UNITED STATES PATENT AND TRADEMARK OFFICE

APPLICATION NO.	FILING DATE	FIRST NAMED INVENTOR	ATTORNEY DOCKET NO.	CONFIRMATION NO.
09/659,172	09/11/2000	Ted A. Lilley	3835.00002	6251

## Office Action Summary

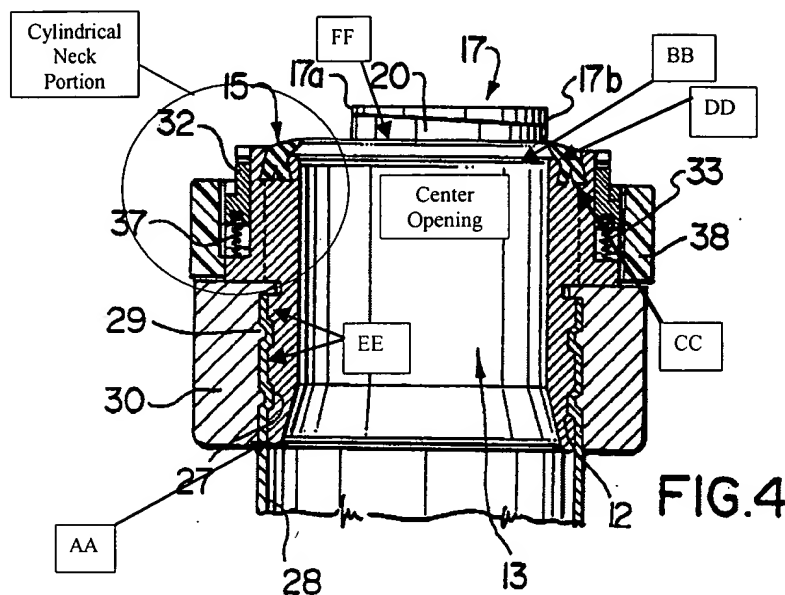
In regards to claim 3, in figure 3 below, Sparling et al discloses each of the locking grooves being further defined by a ramped section (GG) adjacent the second end wall and inclining from the bottom surface towards the front face.

In regards to claim 1, in figure 4 below,

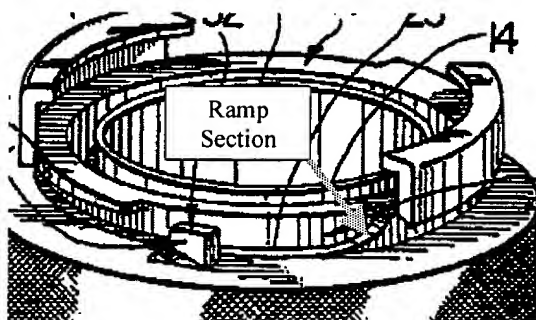
Sparling et al discloses a

hydrant nozzle comprising a tubular body portion (12) extending longitudinally between a first end (AA) and a second end (BB), the body portion having a generally cylindrical outer surface and a generally cylindrical inner surface defining a fluid passageway (13) between the first and second ends, a cylindrical neck portion extending from the second end of the body portion to a front face (16) and having an outer peripheral rim (CC) and an inner rim (DD) defining a center opening in fluid communication with the fluid passageway of the body portion; a pair of spaced apart locking lugs (EE) projecting outwardly from the outer surface and positioned between the first and second ends of the body portion; and a pair of spaced apart arcuate shaped locking grooves (20) recessed in the front face of the neck portion.

In regards to claim 2, Sparling et al discloses each of the locking grooves being defined by a bottom surface (FF) recessed from the front face of the neck portion and extending between spaced apart first and second end walls defining the grooves.
